re: **Site Servicing Plan Review**
Proposed Residential Development
3288 Greenbank Road – Ottawa, Ontario

file: PG5608-MEMO.02

- Site Servicing Plan – SNTC Lands Block 3 – Project No. 160401845 – Drawing No. SSP-1 - Revision 2 – dated March 19, 2024.

Figure 1 - Services Requiring Frost Protection

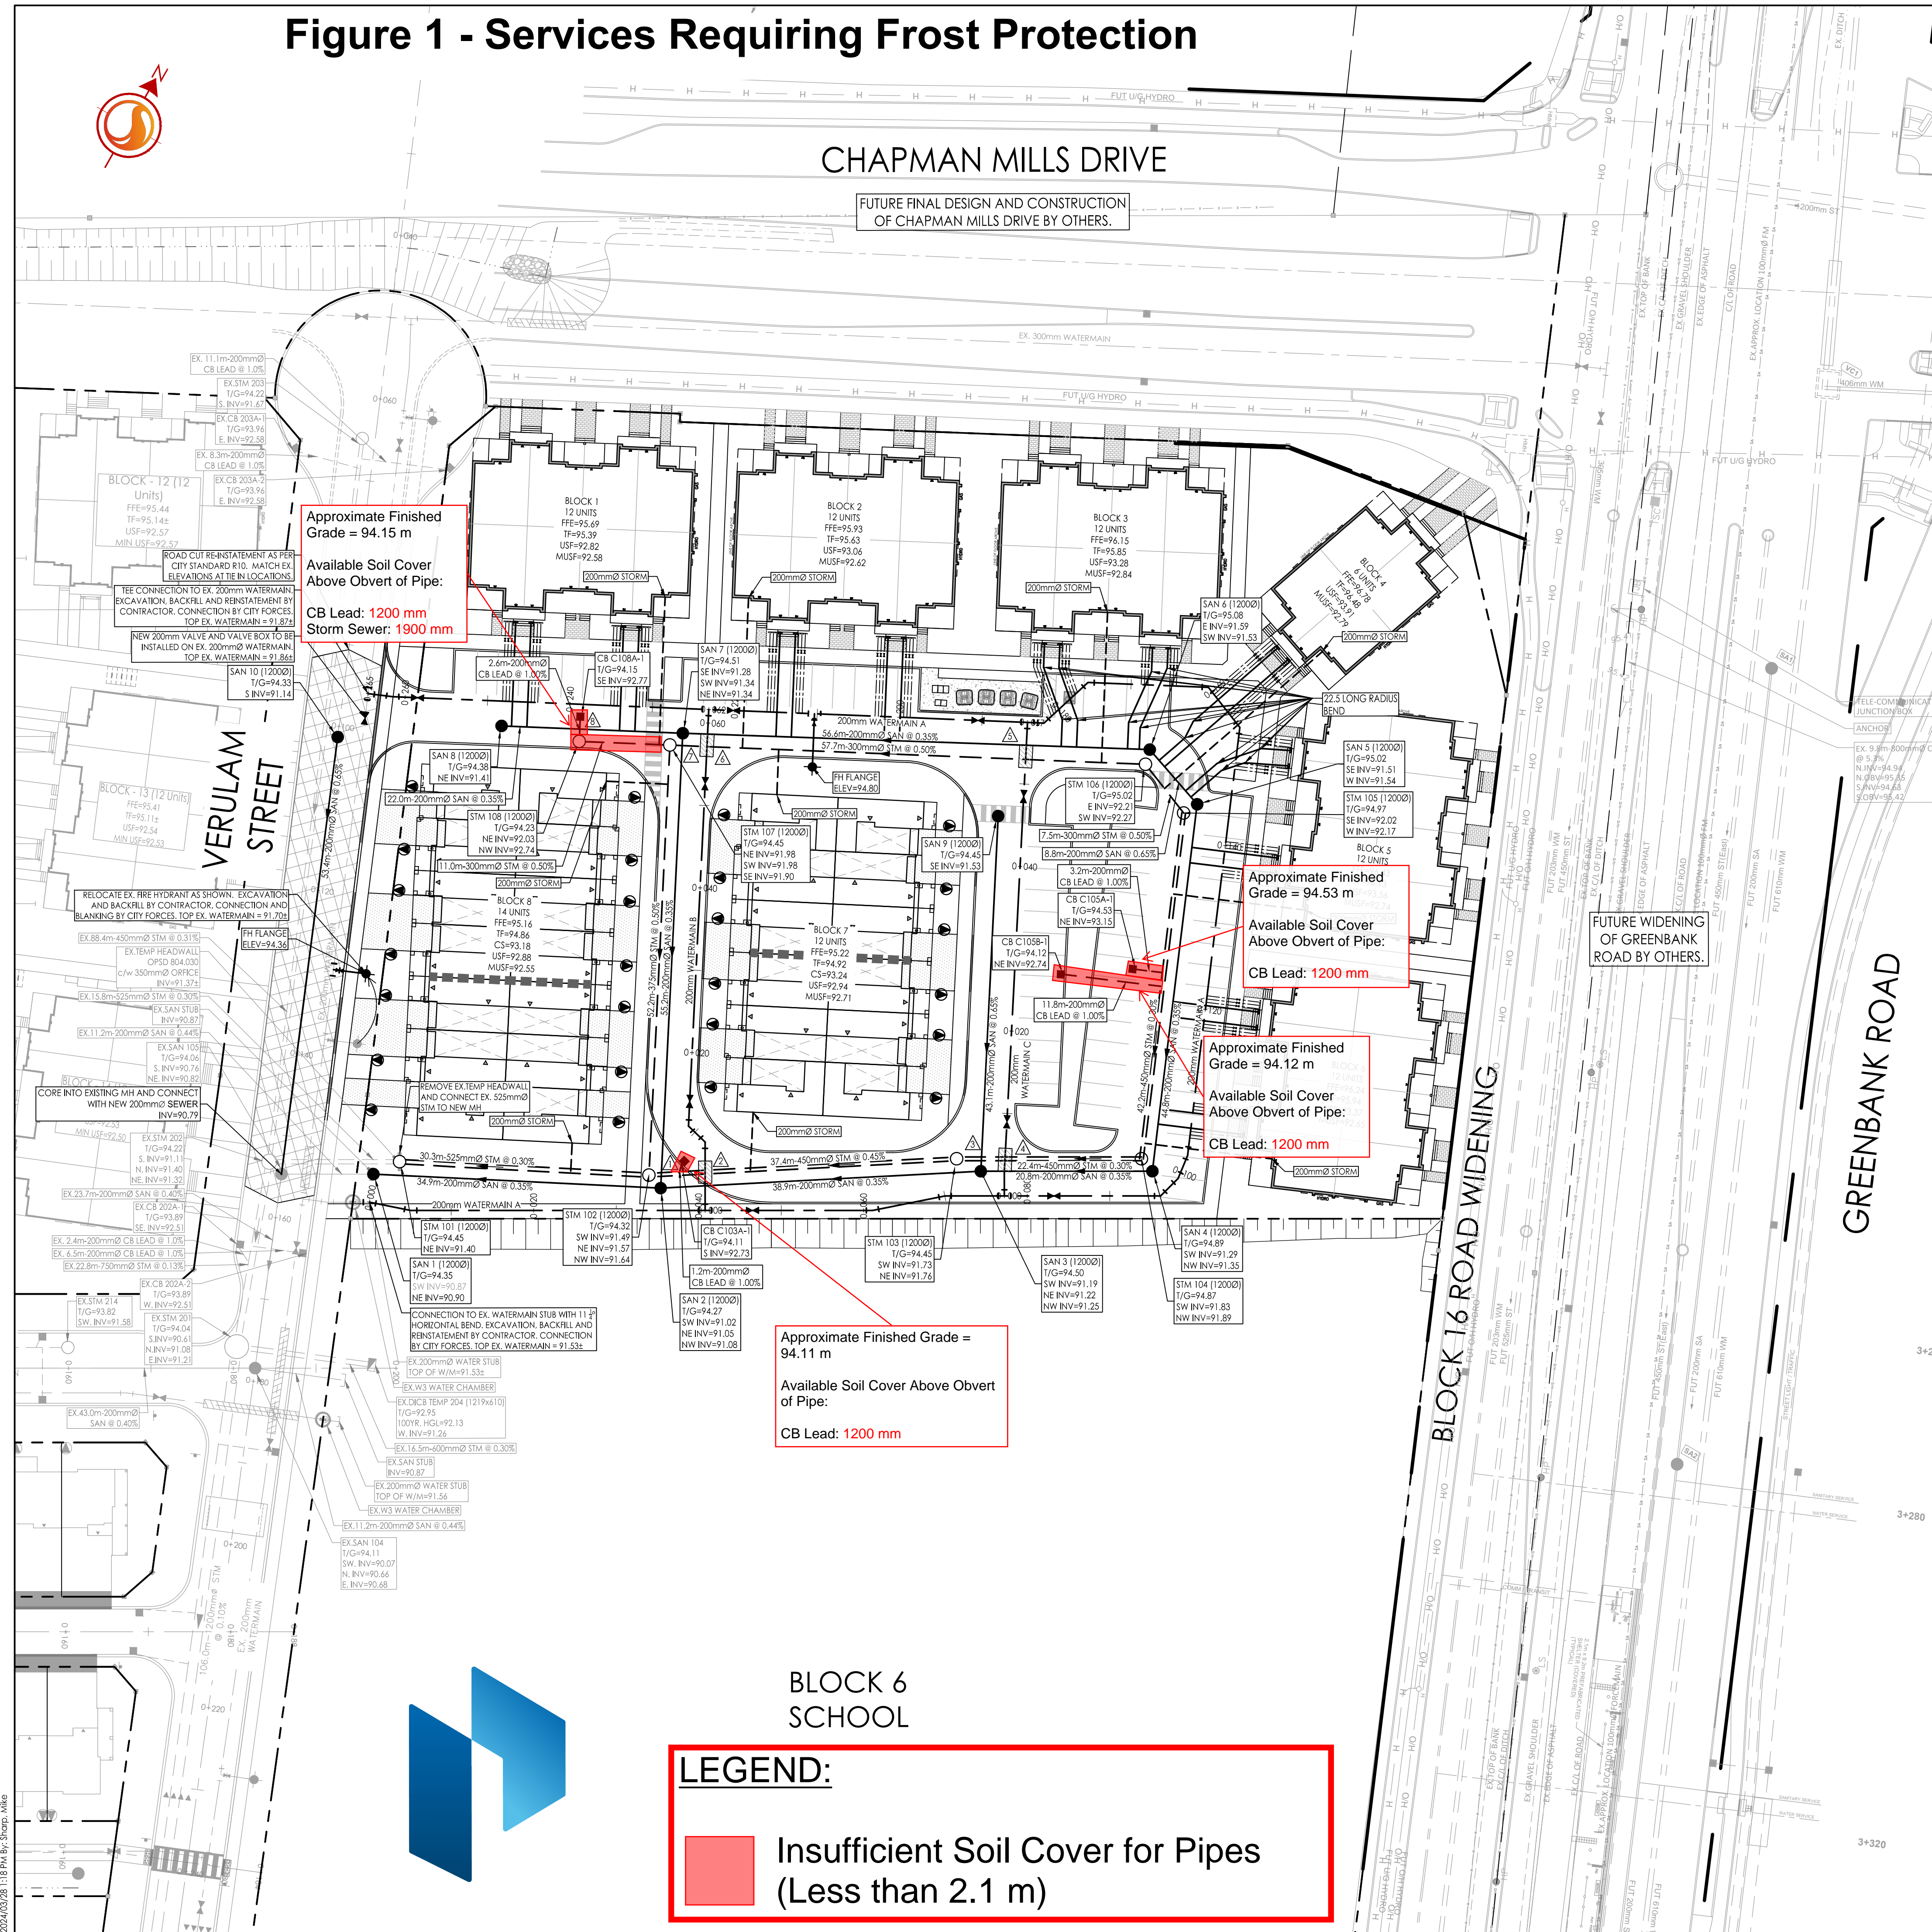
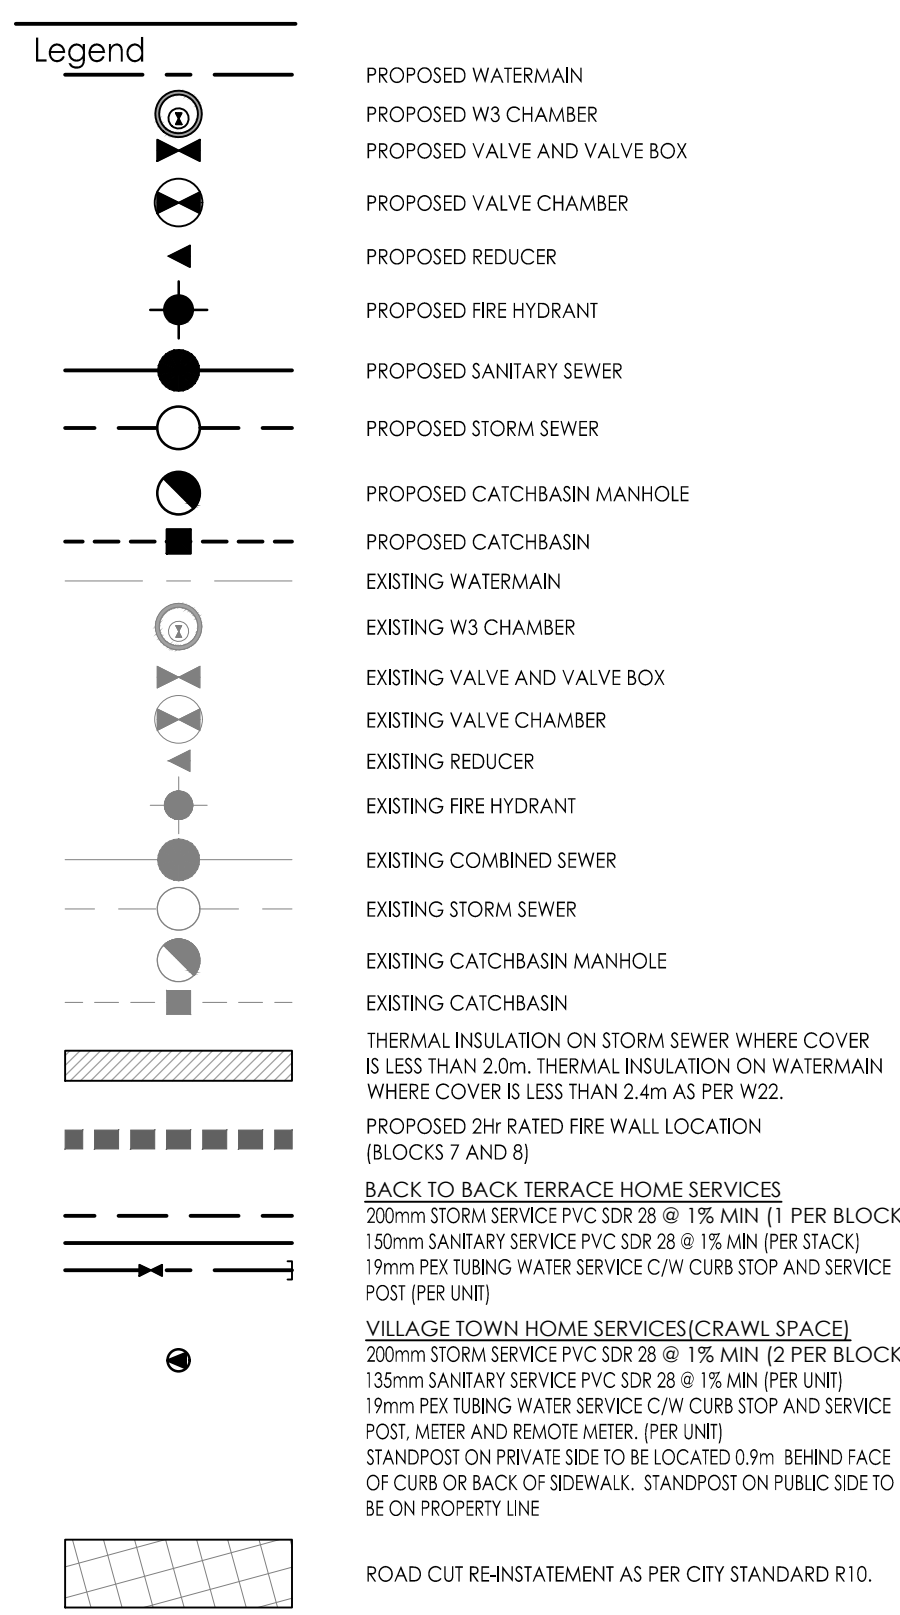
However, insufficient frost protection was noted to have been provided to the storm sewer between STM 108 and STM 107 located within the northwest corner of the site. This section of the storm services will be founded within the frost zone (i.e. approximately 2.1 m below the finished grade). Reference should be made to Figure 1 – Services Requiring Frost Protection, attached to the current memorandum, which illustrates the approximate location. Frost protection of the site servicing is recommended where insufficient frost cover has been provided.

Any portion of the site services installed at a depth of 2.1 m below finished grade or deeper is considered to have sufficient soil cover for frost protection. Where insufficient soil cover is present above the invert of storm sewer pipe, the following frost protection criteria should be followed:

Thermal Condition	Soil Cover Provided (mm)	Insulation Dimensions	
		Thickness (mm)	Extension (mm)
Unheated	600 to 900	125	Extend 1200 mm horizontally beyond edge face of the pipe
	900 to 1200	100	Extend 1200 mm horizontally beyond edge face of the pipe
	1200 to 1500	75	Extend 900 mm horizontally beyond edge face of the pipe
	1500 to 1800	50	Extend 600 mm horizontally beyond edge face of the pipe
	1800 to <2100	25	Extend 300 mm horizontally beyond edge face of the pipe

TYPICAL FROST INSULATION DETAIL

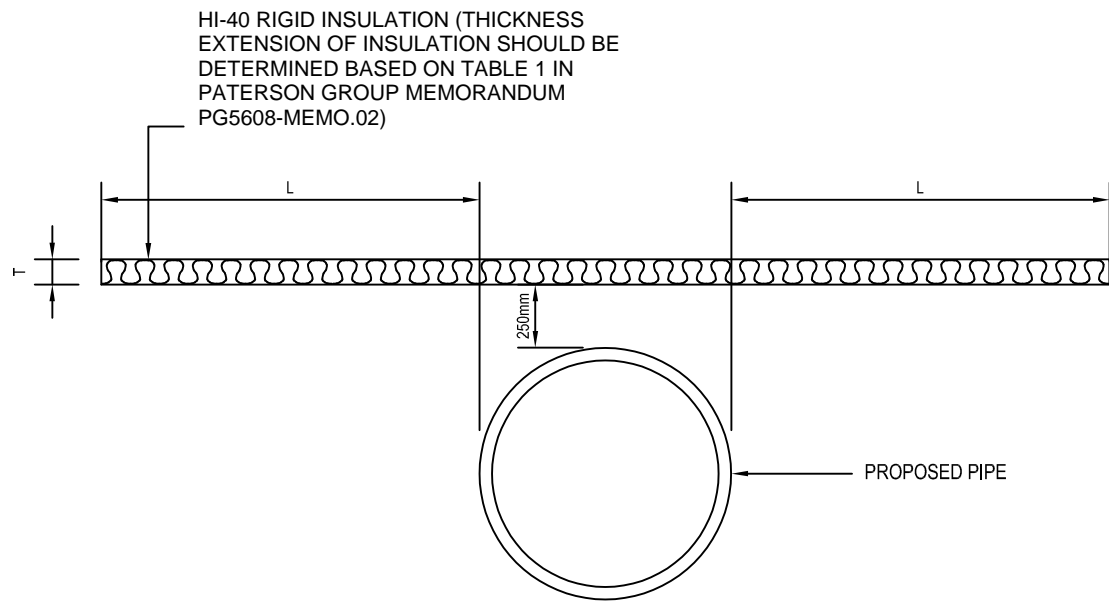
All rigid insulation should consist of either Dow Chemical High-Load 40 (HI-40), Styro Rail SR.P400, or equivalent approved by Paterson. The placement of all insulation within the service trenches must be reviewed and approved by Paterson personnel at the time of construction. Reference should be made to Figure 2 - Typical Frost Insulation Detail, attached to this memorandum.
